DEVELOPMENT MANAGEMENT COMMITTEE – 26 APRIL 2017

Planning document to support the planning objection

Planning Application CB/17/00293/FULL

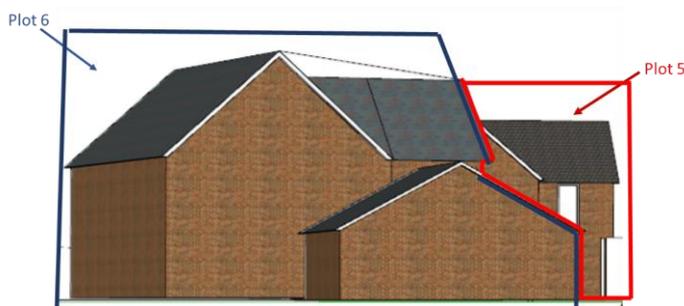
(b) Light in the garden at the base of the wall of the premises

- a. There will no light available in the garden until 11.30 between 12th November and 30th January.

(c) Assuming that we have sun 1/2 way down the garden the use of the garden for drying washing etc will only be available after the following times.

- a. 10.00 am – Between October 18th and 3rd March
- b. 09:30 am – Between October 10th and 10th March.

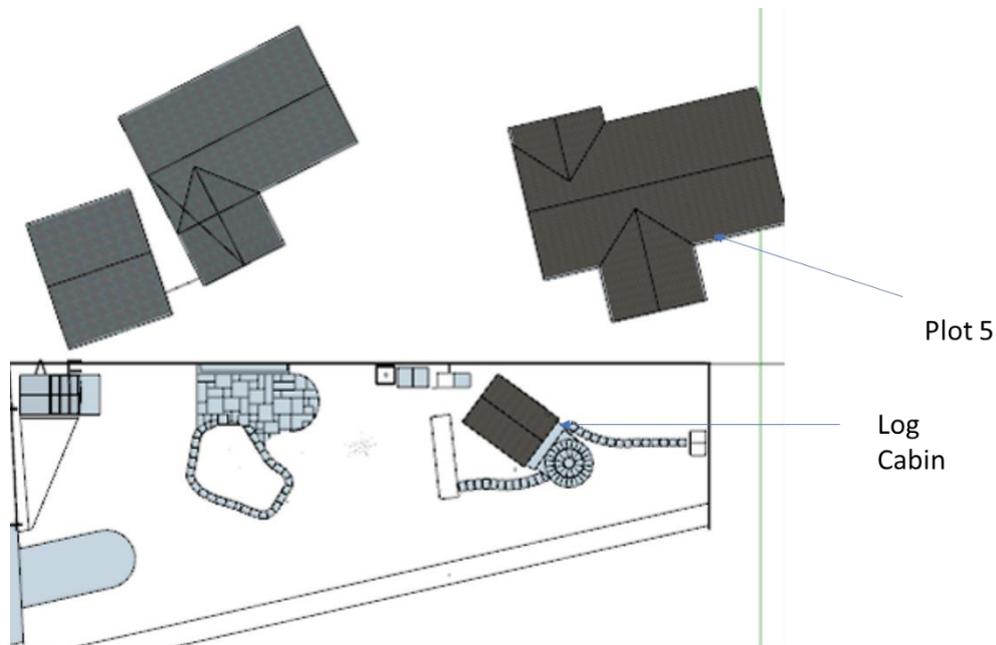
The major concern however relates to the location of Plot 1 coupled with no footpath on the plot. The plan provided indicates traffic will be parked away from the entrance of the site. This is a best case situation and will not be the defacto parking provision by the occupants and visitors to the site. Additionally since, indicated in section 2, the on road parking is only 50% of that required (2 parking spots allocated whereas there should be 4). Some on road parking needs to be allocated elsewhere on the estate and since the parking for plot 1 the norm would be for one car to be in close proximity of the building.

Vehicles will park between Plot 1 and the High Street and this will affect the view of any one entering the site particularly if parked on the bend brought about by Plot 1s position.

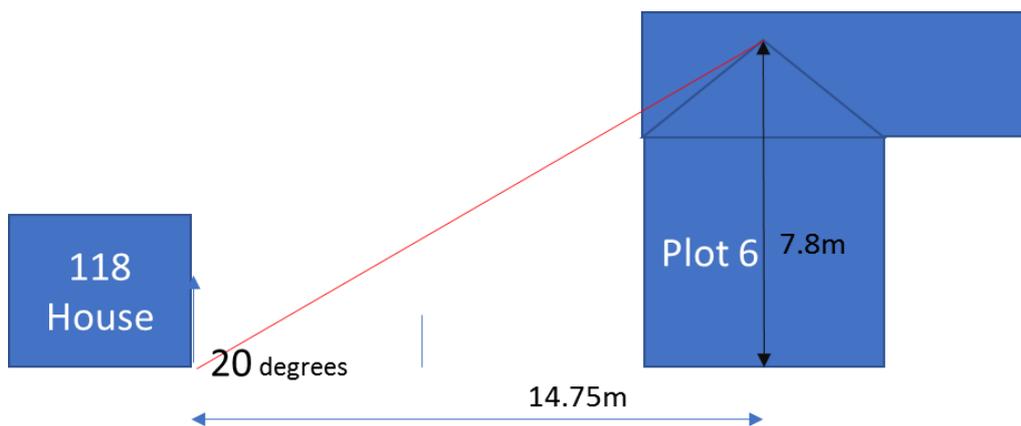
1. 118 High Street is adjacent and virtually to the North of Plot 6.
2. From the plans submitted to support the development the following dimensions have been estimated. Please note to ensure the best case and not the worst case the dimensions have been takes from the secondary ridge identified in Red and not the maid ridge, which is circa 80cm below the main ridge and 3 metre further South.

3. From these the following angles have been calculated.

(c) Fence Boundary.

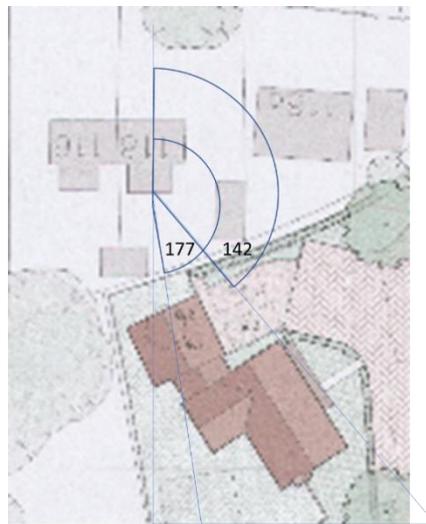
4. From the diagram the best case angle is between 142 from Due North and 177 from Due North.
